Preliminary Soils Evaluation  
 Paula Stephenson  
 Lots 1-5  
 Hobby Road - Harnett County

Adams  
 Soil Consulting  
 919-414-6761  
 Project #653

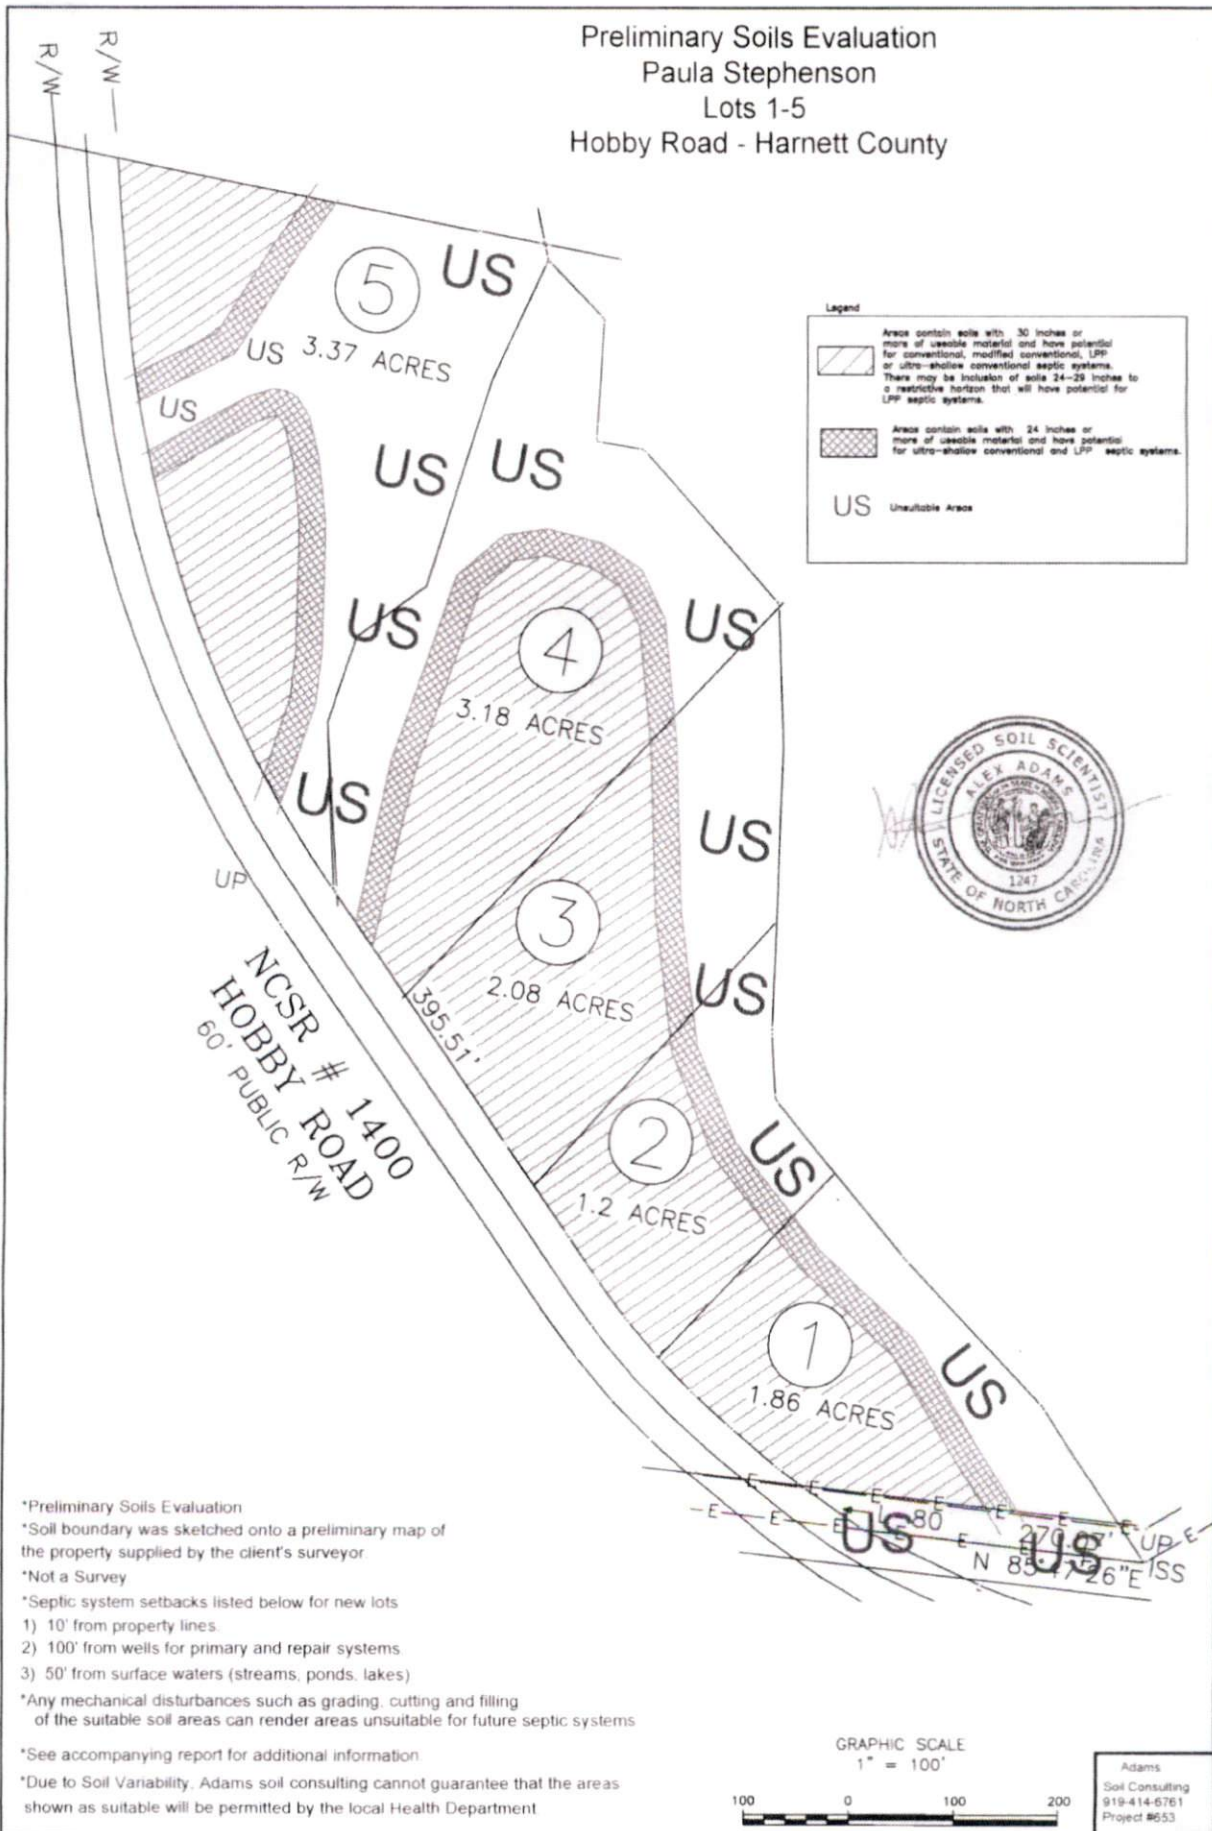
Show profile locations and other site features (dimensions, references or benchmark, and North)

\* Needs I can  
clearly marked  
\* Needs pits
